Changes from V26B include:

Title ALTAIR Photodiode Acquisition Payload - Sergeant (Based on UVic ORCASat design Rev A.6 by Evan Moore)		
Size Tabloid	Number	Revision V26C (V26.4b)
Date:	6-03-2026	Sheet 1 of 6
File:	C:\Users\...\top.SchDoc	Drawn By: Nicholas Sandor

Size	Number	Revision
Tabloid		V26C (V26.4b)
Date:	6-03-2026	Sheet 3 of 6
File:	C:\Users\...\Power.SchDoc	Drawn By: Nicholas Sandor

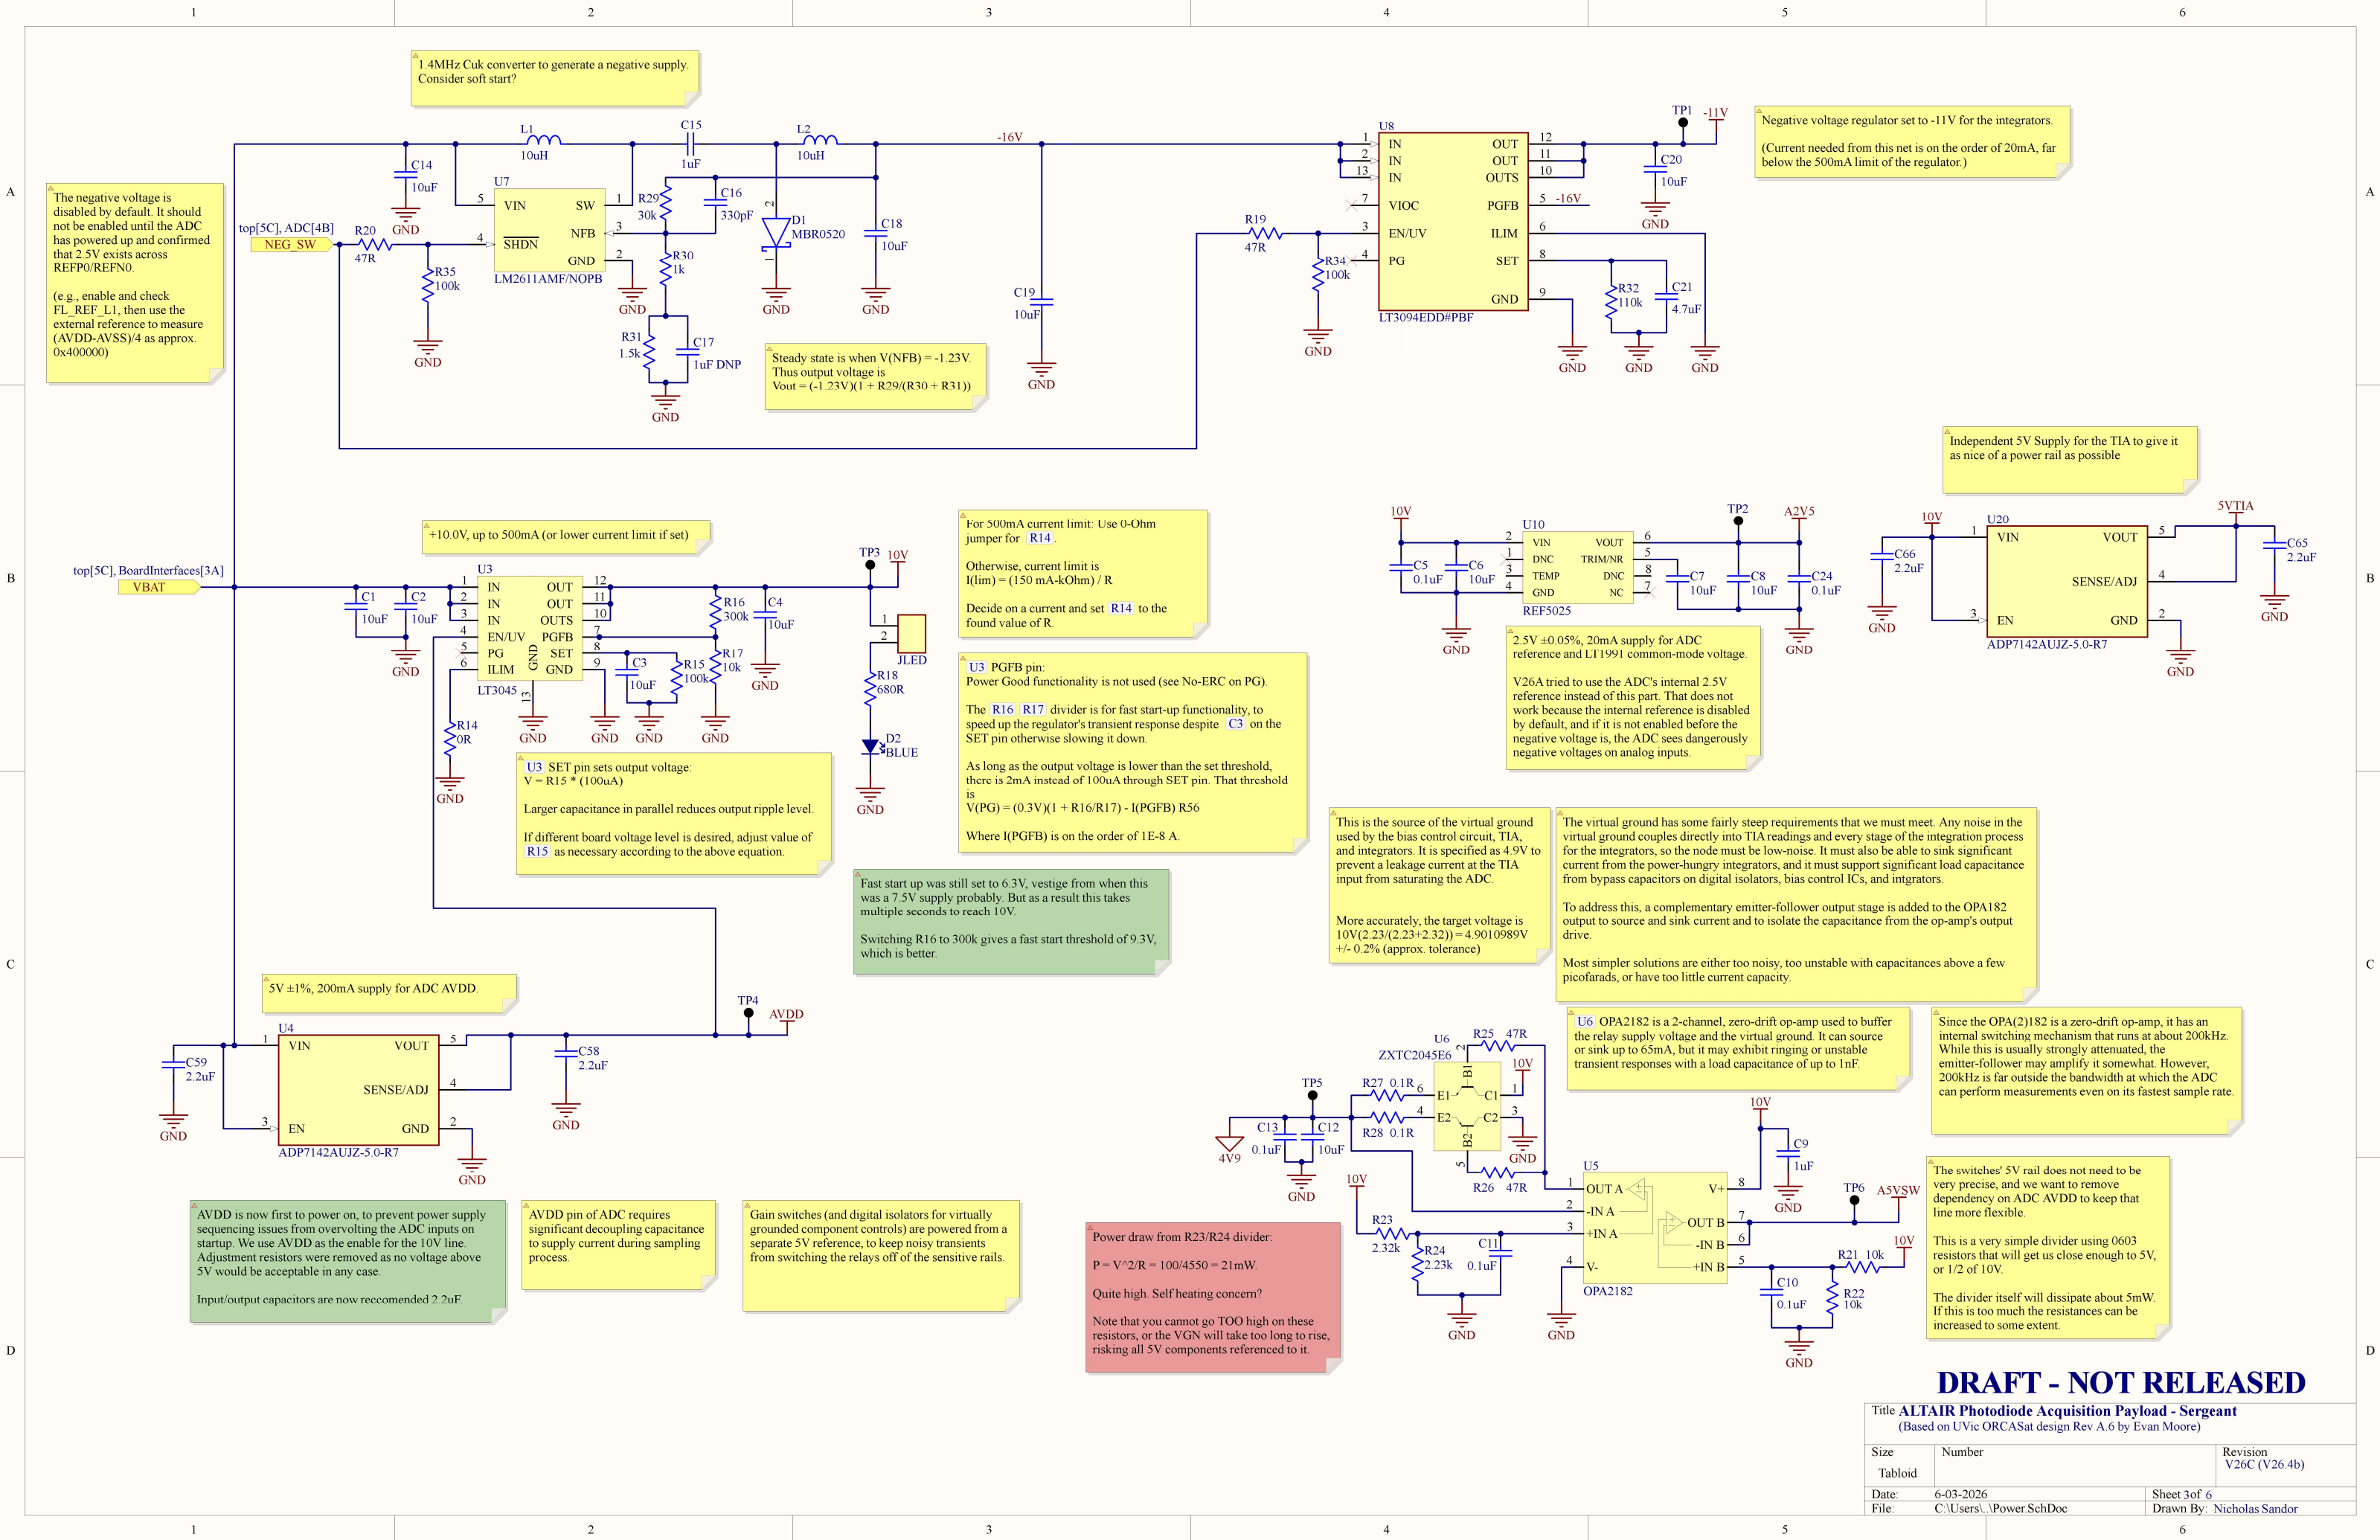
1.4MHz Cuk converter to generate a negative supply. Consider soft start?

Fast start up was still set to 6.3V, vestige from when this was a 7.5V supply probably. But as a result this takes multiple seconds to reach 10V.

Power draw from R23/R24 divider: $P = V^2/R = 100/4550 = 21mW$.

Quite high. Self heating concern?

Switching R16 to 300k gives a fast start threshold of 9.3V, which is better.

Title ALTAIR Photodiode Acquisition Payload - Sergeant (Based on UVic ORCASat design Rev A.6 by Evan Moore)		
Size	Number	Revision
Tabloid		V26C (V26.4a)
Date:	6-03-2026	Sheet 4 of 6
File:	C:\Users\U.TIA.SchDoc	Drawn By: Nicholas Sandor

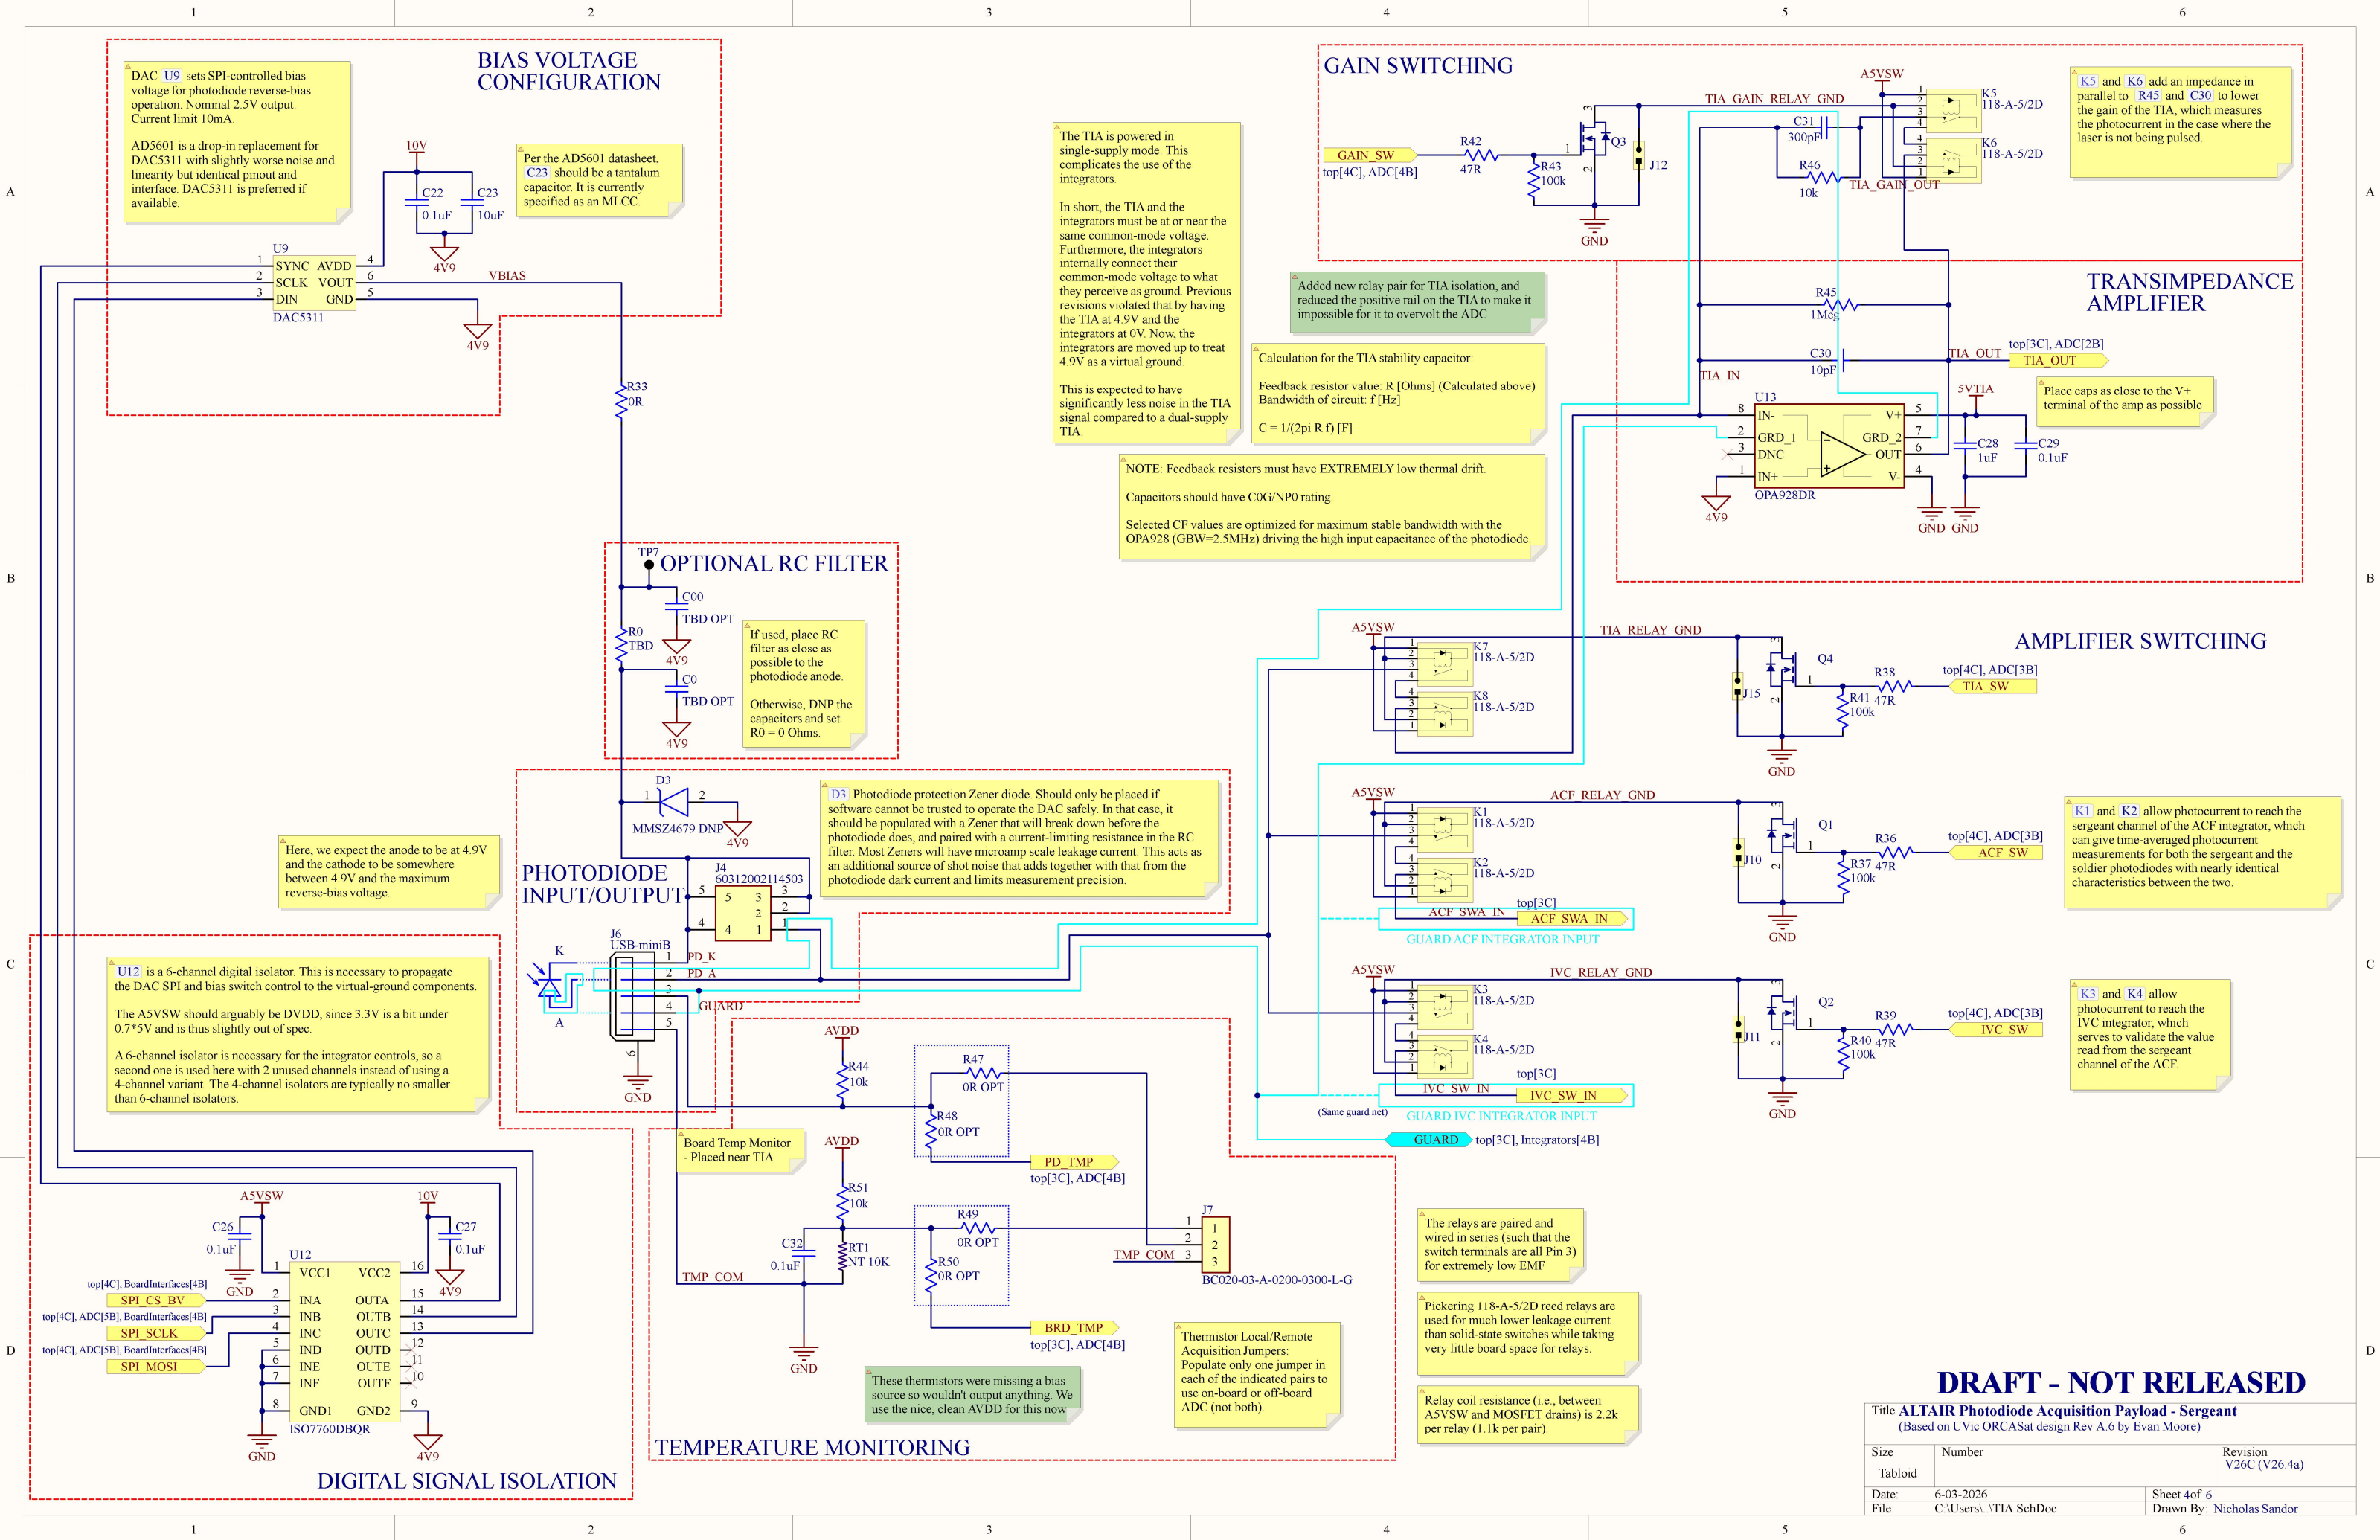
Added new relay pair for TIA isolation, and reduced the positive rail on the TIA to make it impossible for it to overvolt the ADC

Per the AD5601 datasheet, C23 should be a tantalum capacitor. It is currently specified as an MLCC.

These thermistors were missing a bias source so wouldn't output anything. We use the nice, clean AVDD for this now
